DESIGNED <i>JWM</i>	REVISED - ADDENDUM A 02/22/2013
DRAWN <i>RES</i>	REVISED -
CHECKED <i>JRS</i>	REVISED -
DATE <i>12/14/2012</i>	REVISED -

PROPOSED DRAINAGE PLAN & PROFILE - ILLINOIS ROUTE 59

F.A.P. RTE.	SECTION	COUNTY	TOTAL SHEETS	SHEET NO.
338	(112 & 113) WRS-7	DUPAGE	734	302
DP-03		CONTRACT NO. 60R31		
FED. ROAD DIST. NO. ILLINOIS FED. AID PROJECT

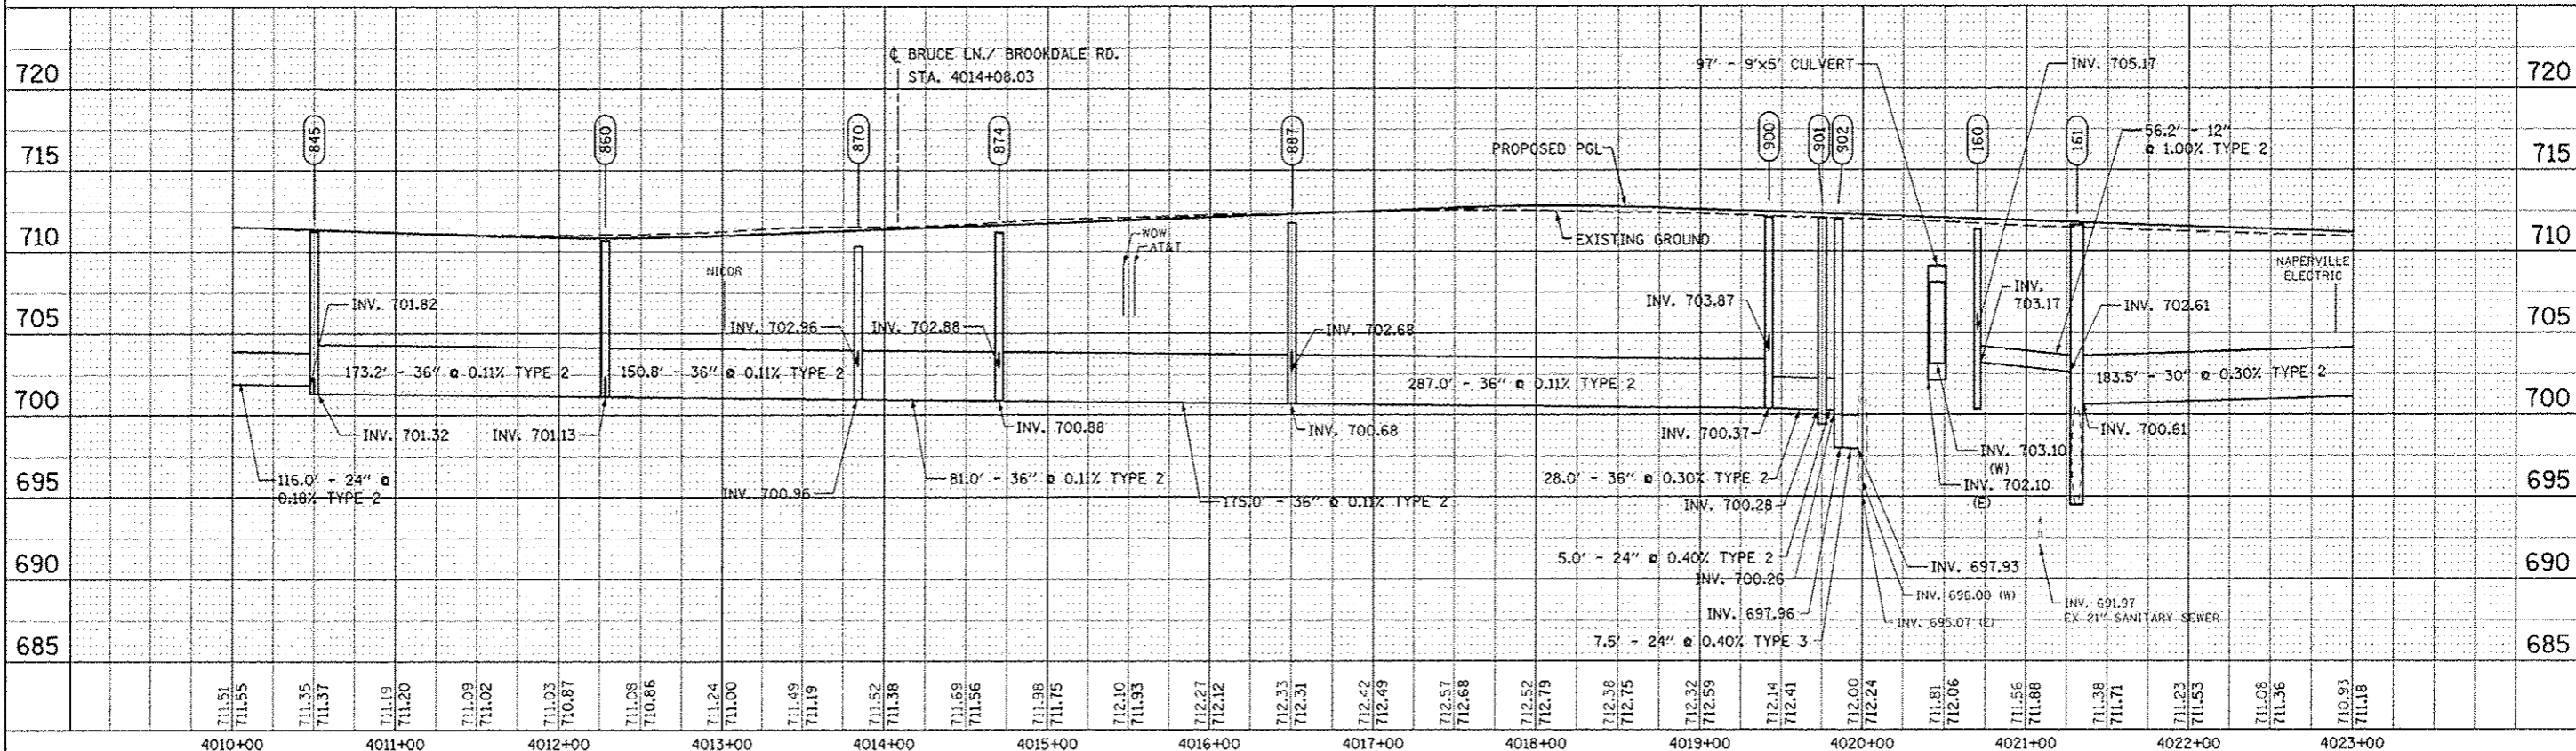
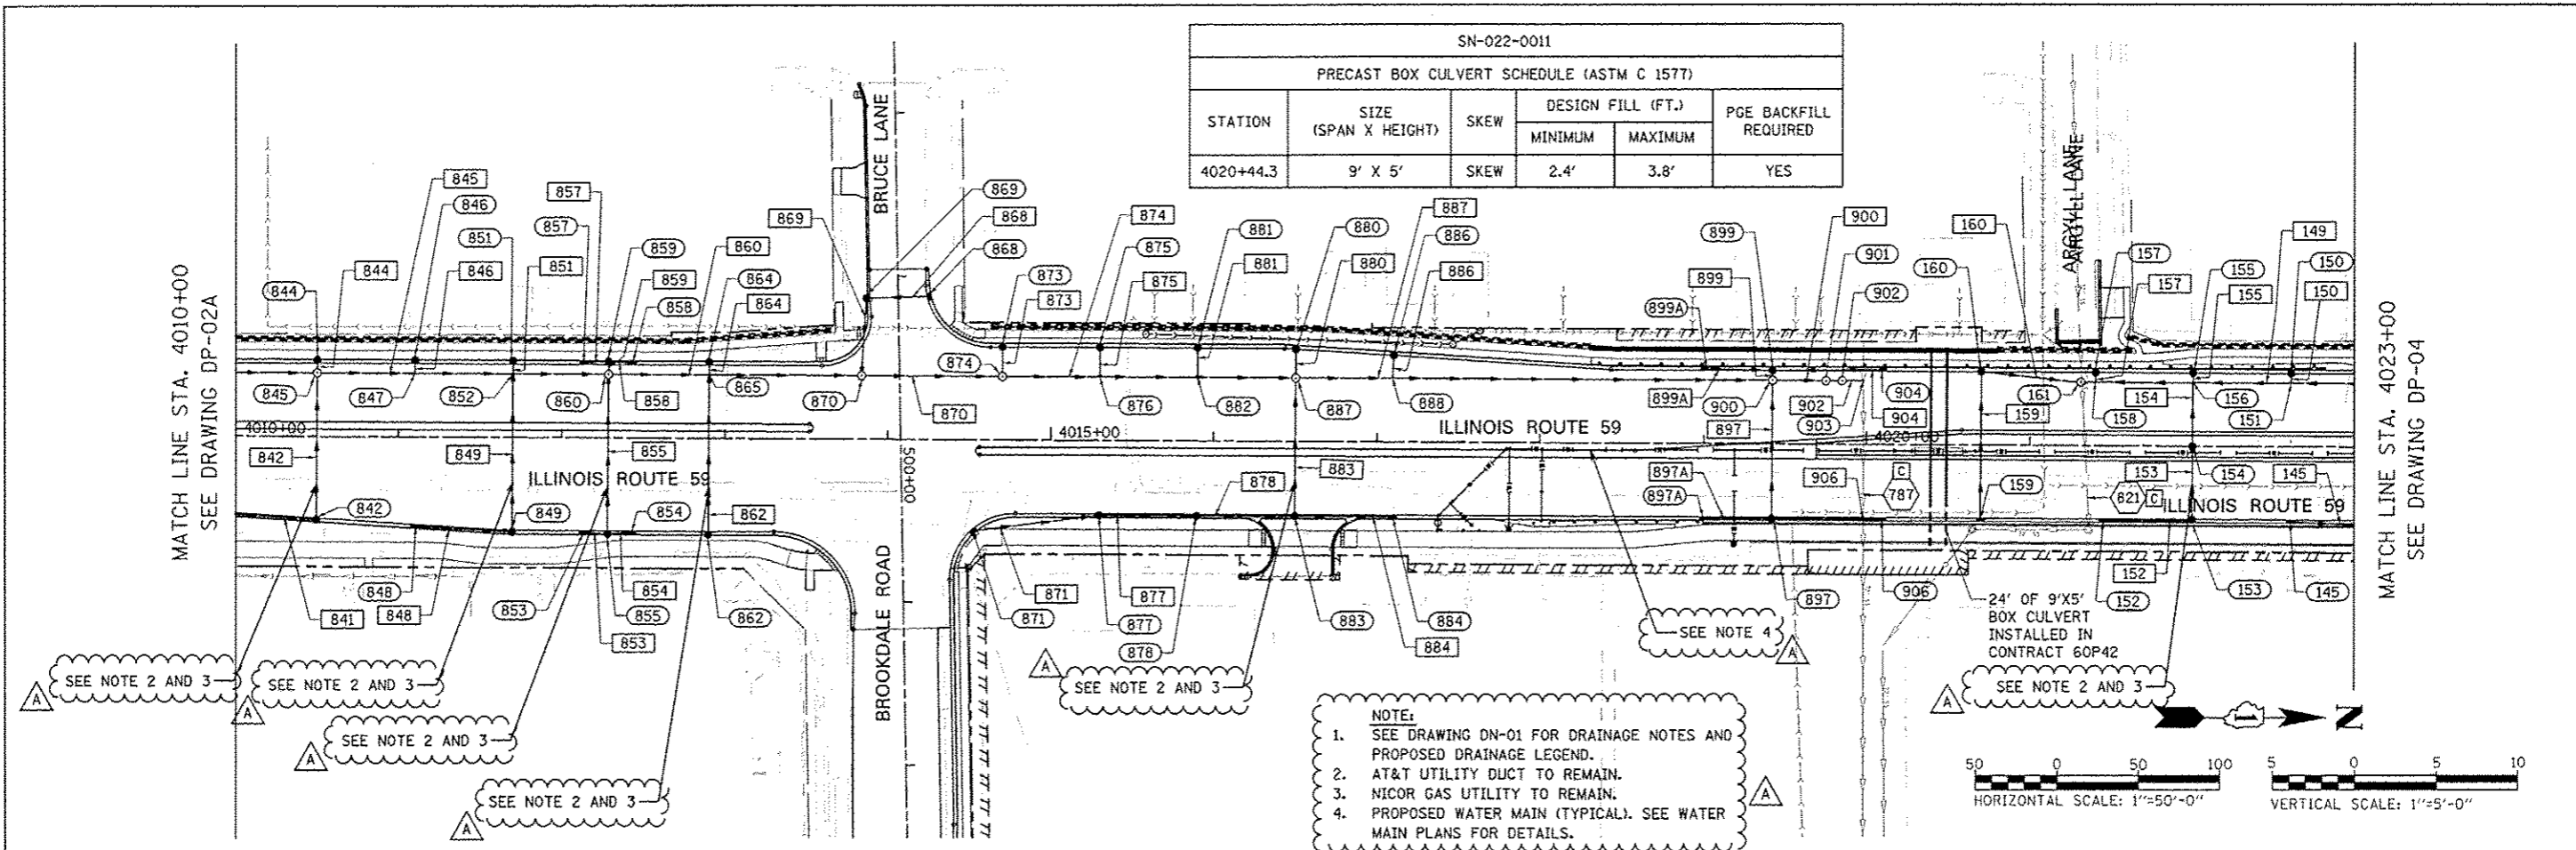
SN-022-0011					
PRECAST BOX CULVERT SCHEDULE (ASTM C 1577)					
STATION	SIZE (SPAN X HEIGHT)	SKEW	DESIGN FILL (FT.)		PGE BACKFILL REQUIRED
			MINIMUM	MAXIMUM	
4020+44.3	9' X 5'	SKEW	2.4'	3.8'	YES
